**Addendum No. 2**  
**November 17, 2021**

Project: Corsica-Stickney H.S. Addition  
Corsica, South Dakota  
Architect's Project No.: 2910

Architect: Architecture Incorporated

**3.56**

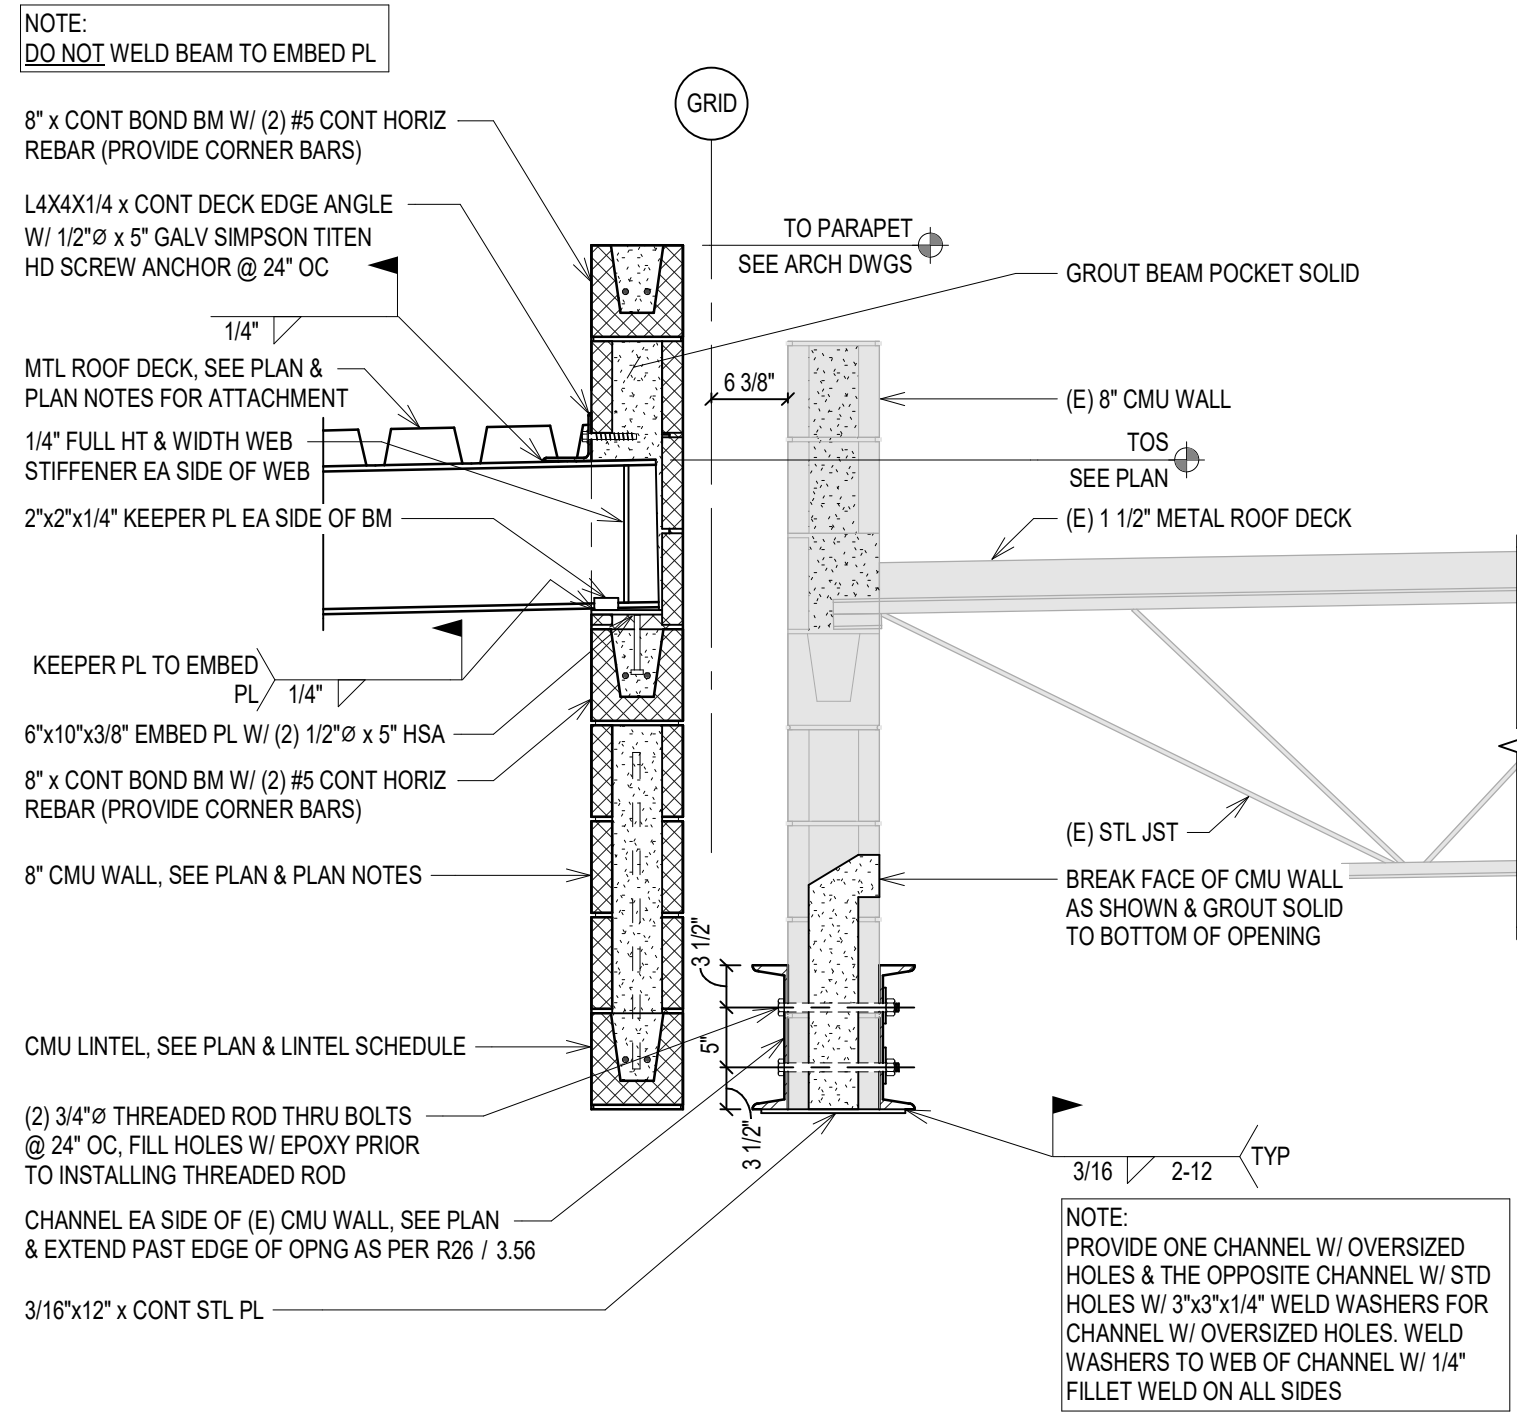
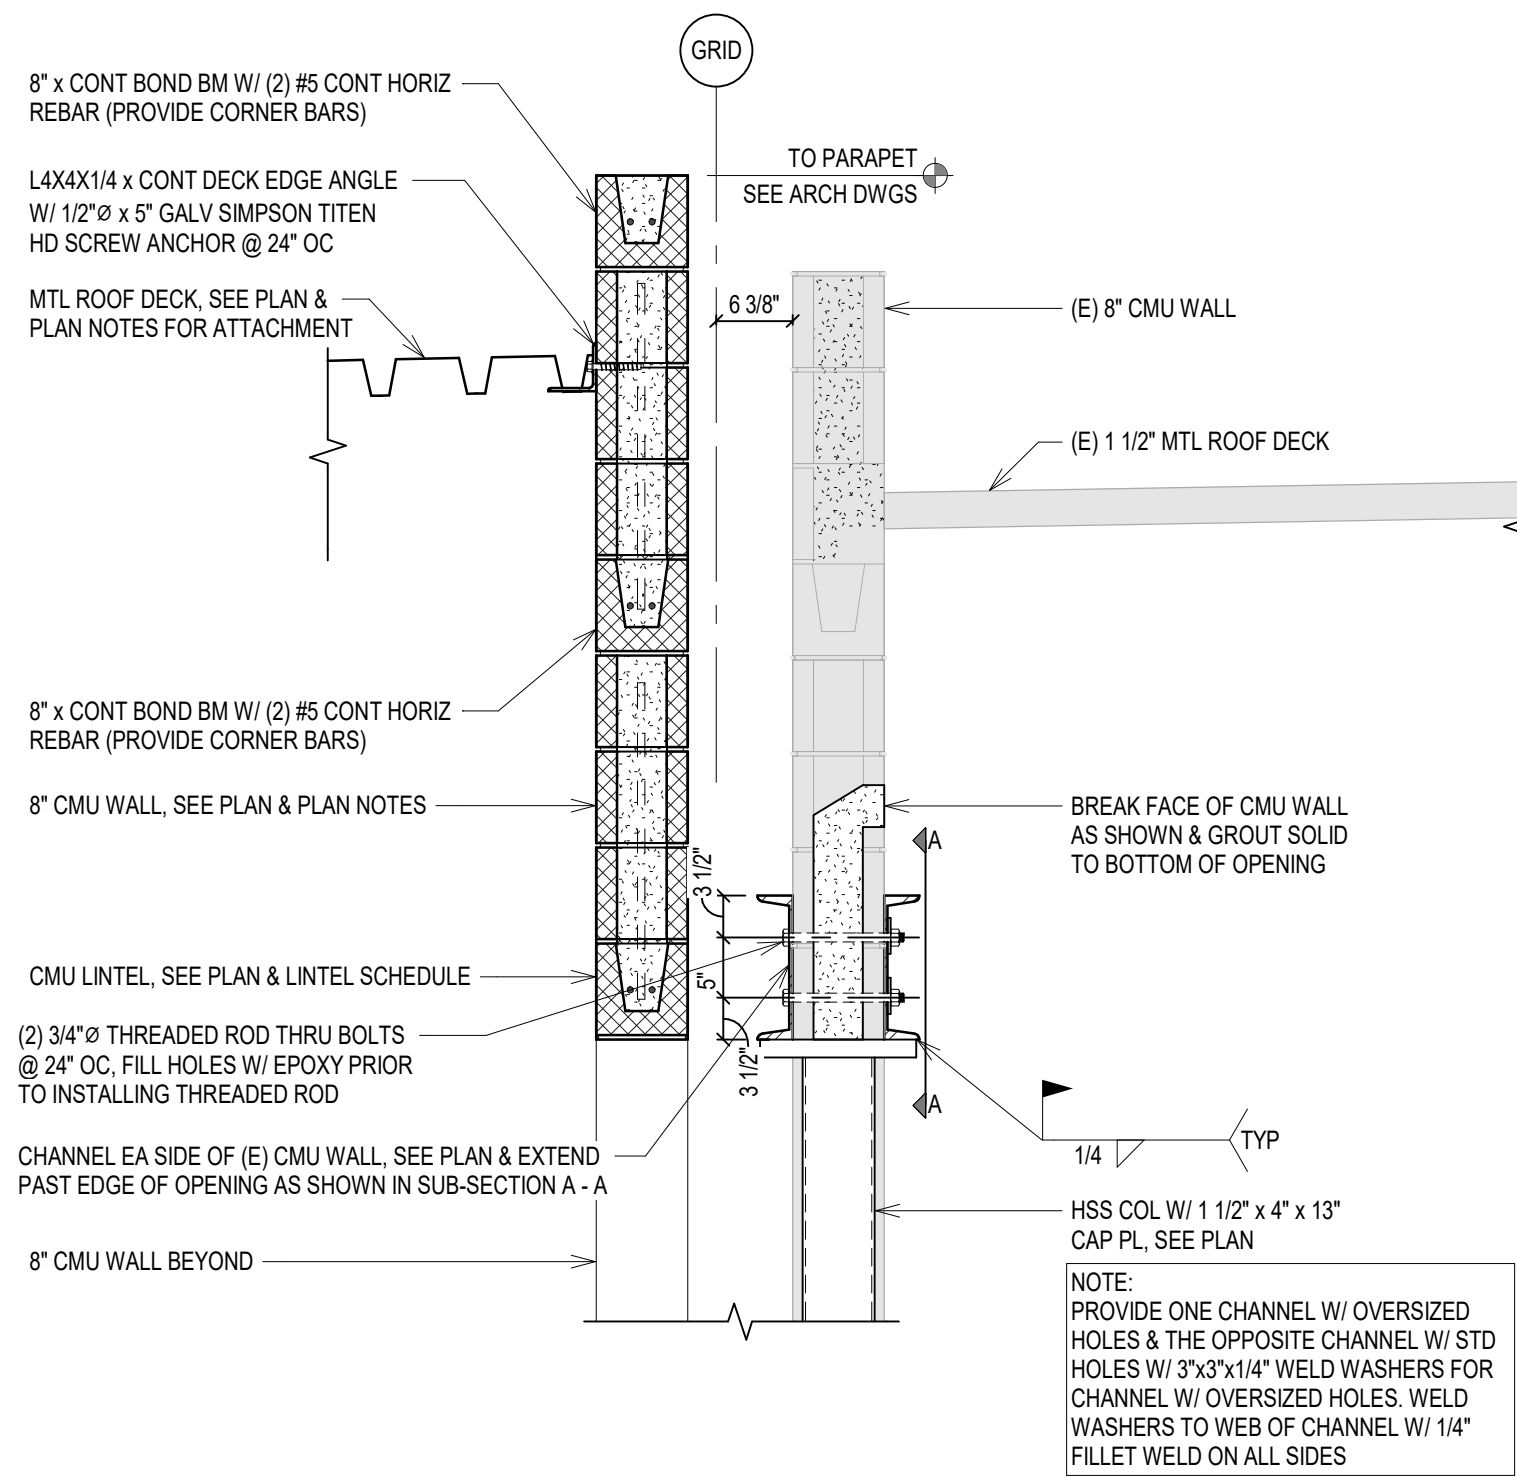
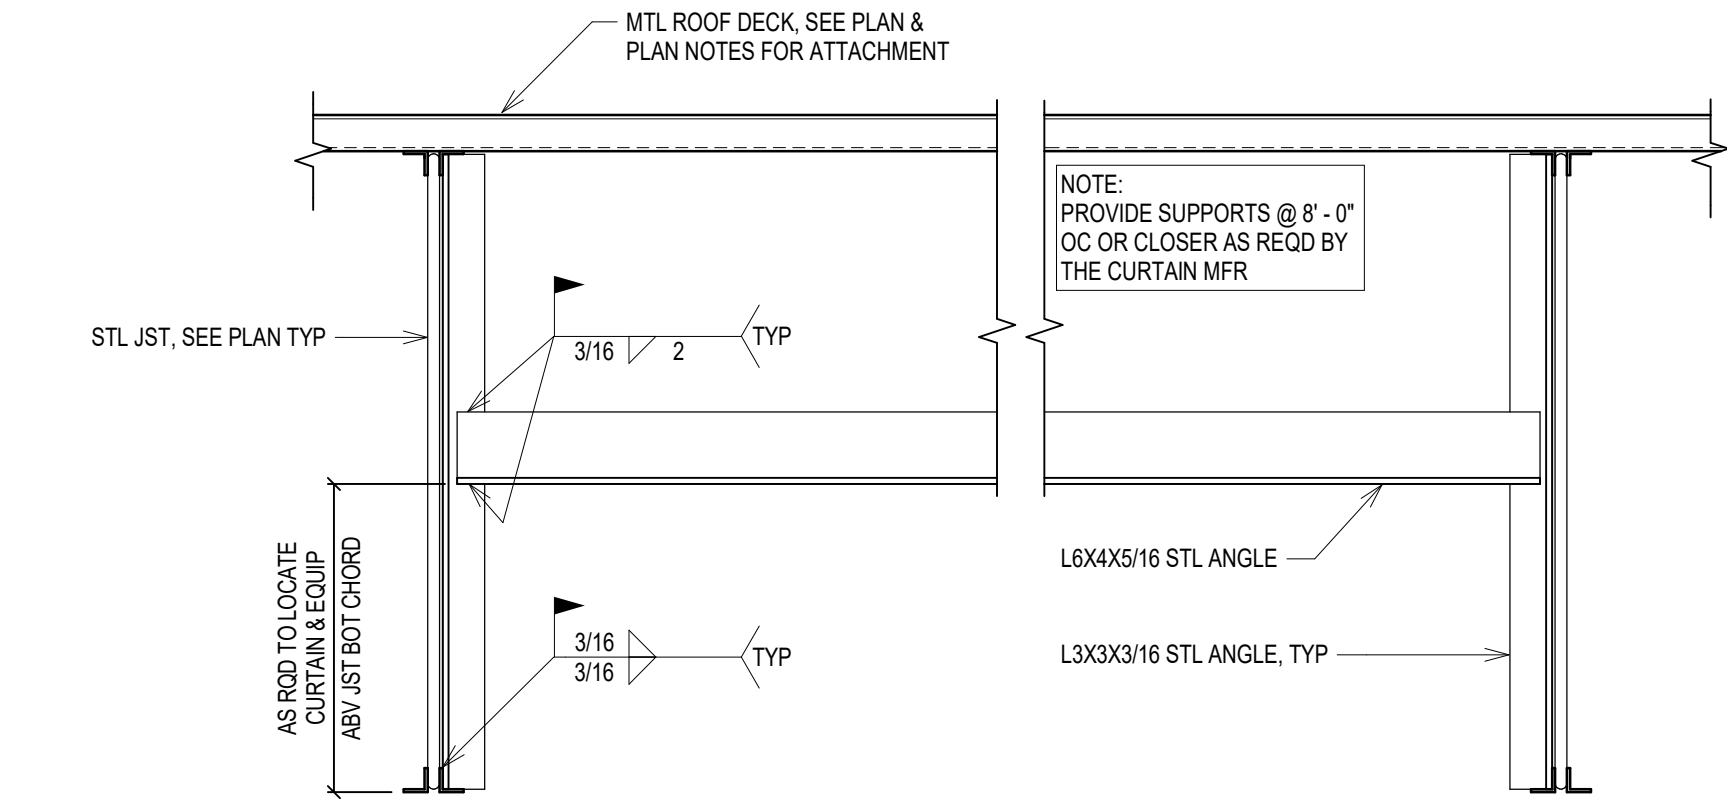
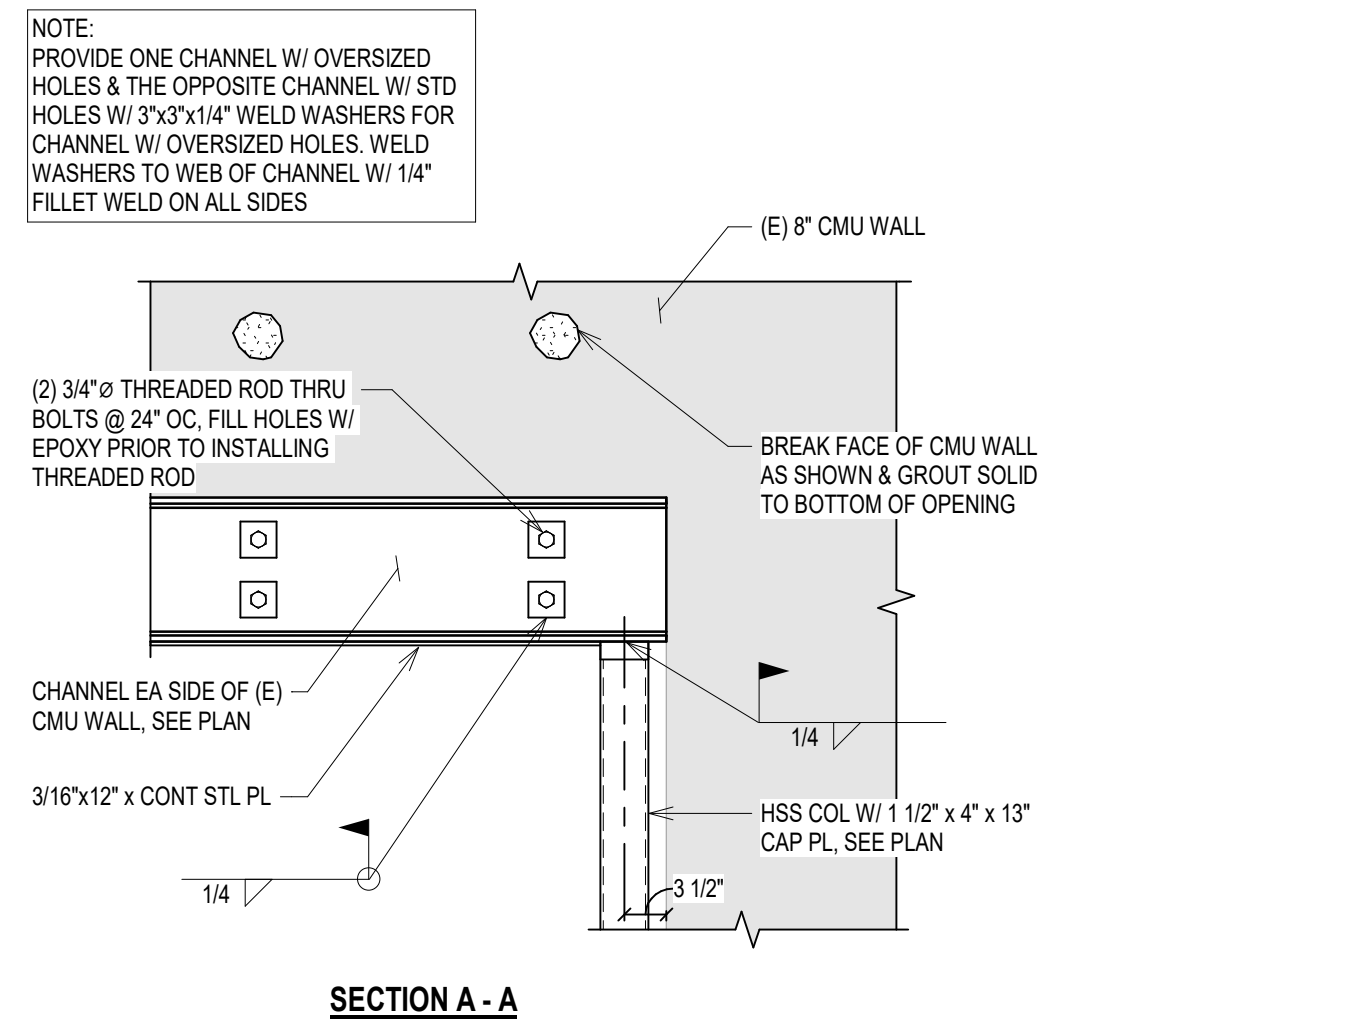
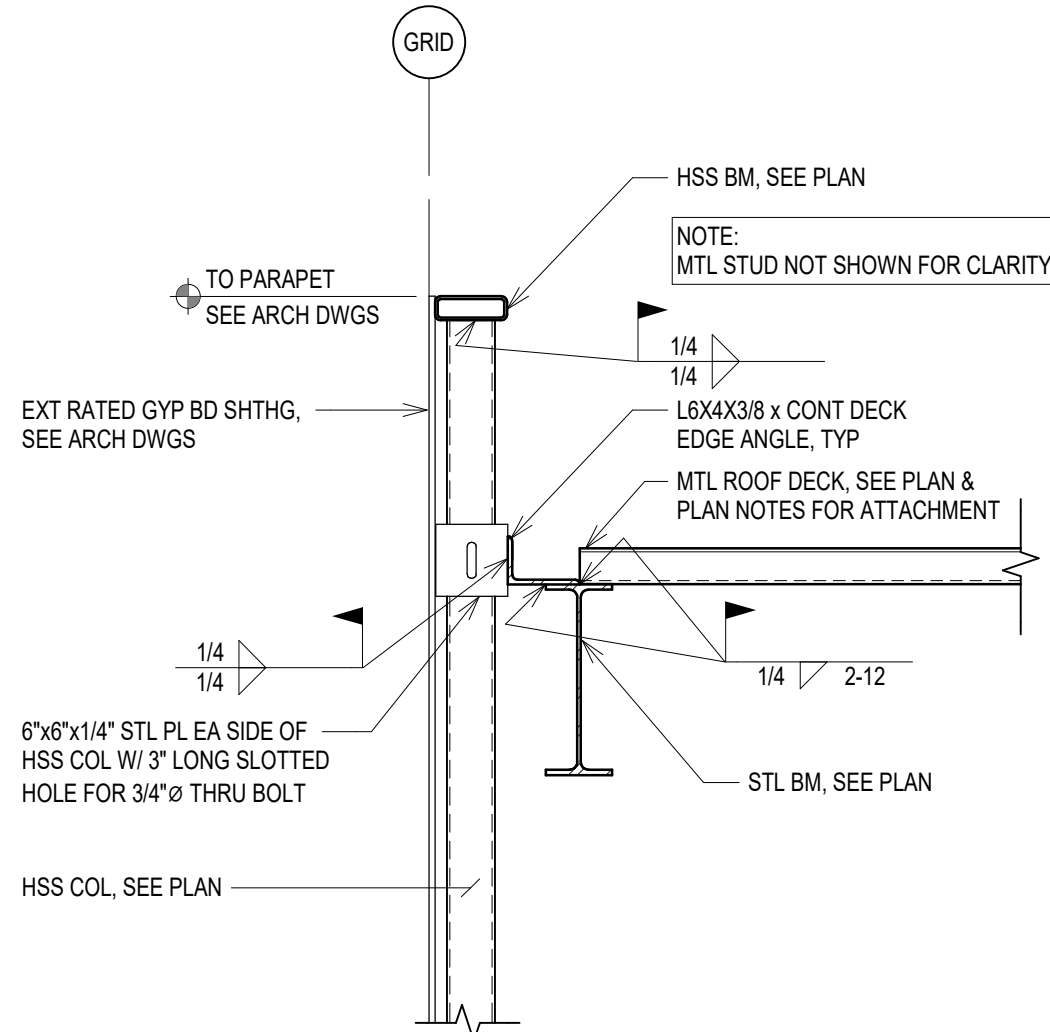
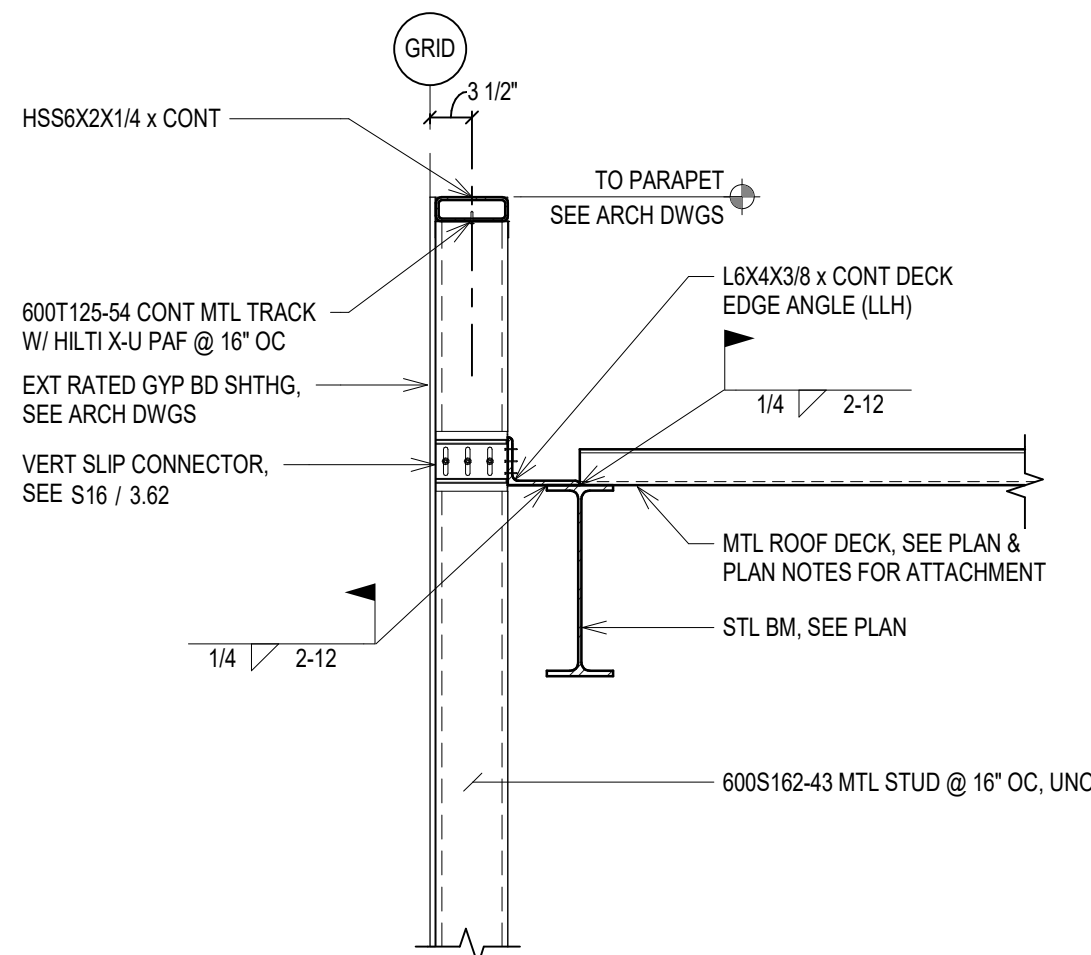
- iii) SHEET 3.56 – DETAILS
    - iv) SHEET 3.57 – DETAILS
    - v) SHEET 3.58 – DETAILS
- 9) **SHEET 5.11 WINDOWS AND STOREFRONTS:** See new sheet clouded and tagged with “2”
